Application Ref: HGY/2023/0636

Site Address: Flat 1, 41 Endymion Road, Hornsey N4 1EQ

Proposal: Erection of a single dwelling house with a basement floor

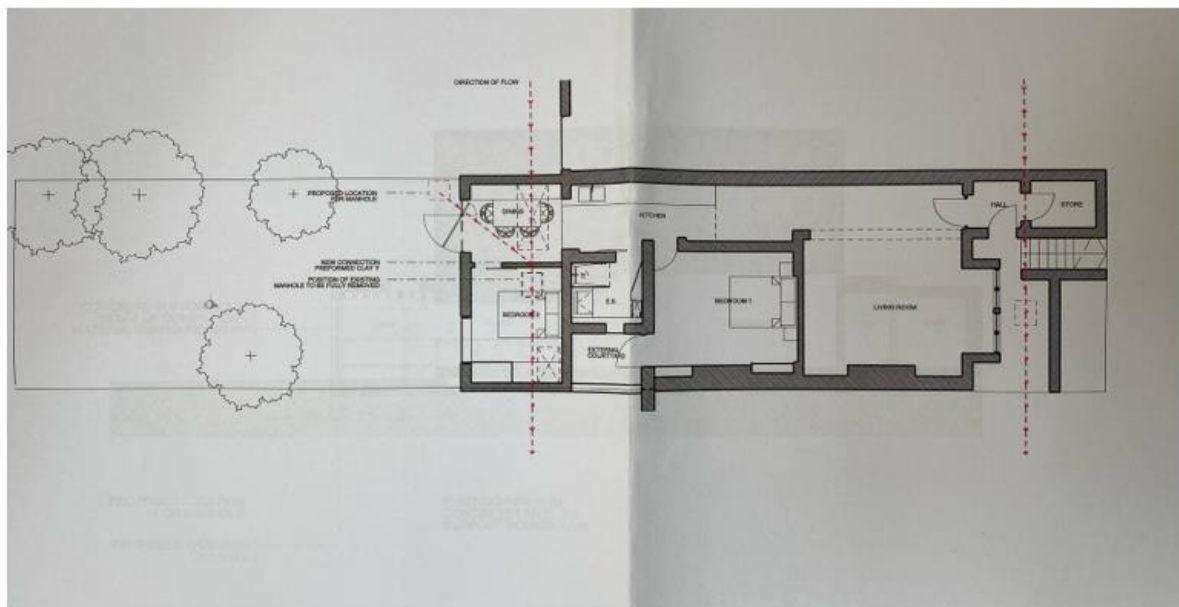
In the absence of a professional study, I have sketched up a diagram of the likely overshadowing effect below. This demonstrates that more than 50% of my client's garden (the area coloured blue) will be completely overshadowed by the proposed development and the rest of the garden will receive significantly less sunlight.

Most of the garden currently receives sunlight from about midday until about 5.30pm (5.5 hours) and in mid-summer from late morning until late evening (approximately 9 hours). The proposed dwelling would block the afternoon sun and result in only a small area of garden receiving sunlight for a short amount of time (approximately 3 to 4pm depending on the time of year). The garden would therefore no longer be a pleasant place to be in, with only approximately 1 hour of sunlight per day in a small section of the garden, and a 7.5m high wall along much of the boundary.

The end of the garden (coloured blue) is currently the part of the garden where my client receives the most amount of sunlight and therefore this is where the seating area is positioned and where the most time is spent in the garden. This area would be completely overshadowed by the development which would also put all the trees and shrubs into shadow. There are a number of trees close to the proposed dwelling that would also suffer from significant root damage and would likely not survive.

Floor plan of Flat A 42 Endymion Road (not to scale)

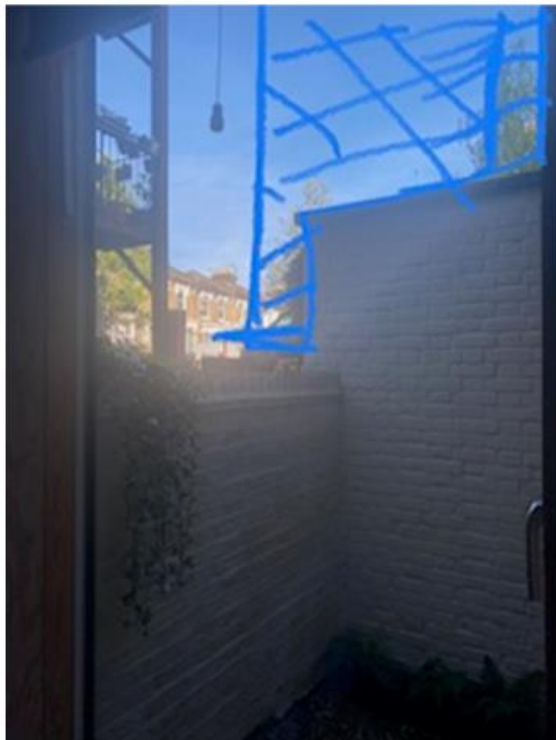
3. There would be significant loss of daylight and outlook to the main bedroom, the 2nd bedroom, and the dining room of my client's property as a result of the proposed development (see the floor plan and photos of my client's property below). These rooms are single aspect rooms and at lower ground floor height, therefore they already have limited light and outlook. This will have a significant impact on my client's property because these rooms account for approximately 50% of the total floorspace, and the kitchen also relies on natural light from the dining room. The existing location plan and block plan submitted with the planning application does not show my client's property correctly (the rear extension is missing) and therefore cannot be properly assessed based on the drawings submitted. I have added the rear extension to my diagram above to but it needs to be formally added to the drawings being assessed in the application.
